February 2, 2026

**RE: Comments on Proposal 237, 2025 RTEP Window 1 MAAC Regional Cluster  
Competitive Solution 2025-W1-237**

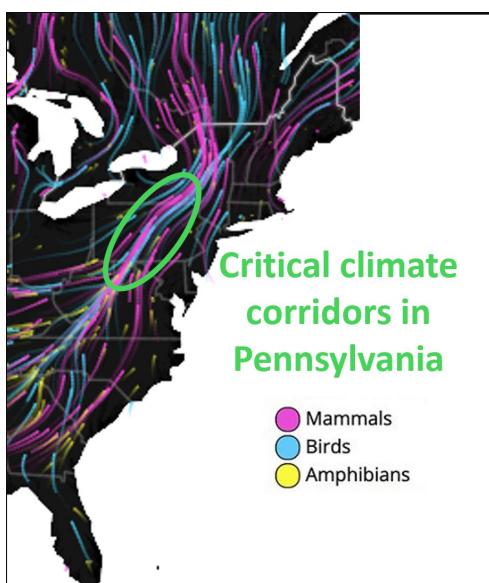
Proposal 237, without additional co-location, would likely create significant impacts to critical climate migration corridors in Pennsylvania that will be difficult to offset. The proposed route traverses most of the north-to-south ridgelines that serve as habitat bridges and migration pathways from the southern Appalachians to the northern Appalachians (see embedded Maps 1 and 2 below).

TNC strongly advocates for the sequential and iterative application of the mitigation hierarchy for all major energy infrastructure projects, especially for Project 237, given its significant impact on critical climate corridors in Pennsylvania, as shown. Earnest application of this hierarchy requires the project developer and PJM to use evidence-based best practices across the full project cycle—from pre-feasibility planning to decommissioning – to deliver No Net Loss (NNL) to priority habitats and species at the project level. The so-called mitigation hierarchy, as it is globally known, provides the fundamental framework for energy projects to mitigate biodiversity loss and is a common requirement in permitting.<sup>2</sup>

For Proposal 237, we encourage robust, transparent, science-based reassessment of the proposed route. Ideally, proposed transmission routes will maximize co-location with existing ROWs, particularly along route segments parallel to existing lines. In addition, we encourage efforts to incorporate new approaches to reduce land-use impacts, including, but not limited to, co-locating with existing transportation ROW, reconductoring existing infrastructure, and rerouting to maximize the use of degraded lands along the pathway.
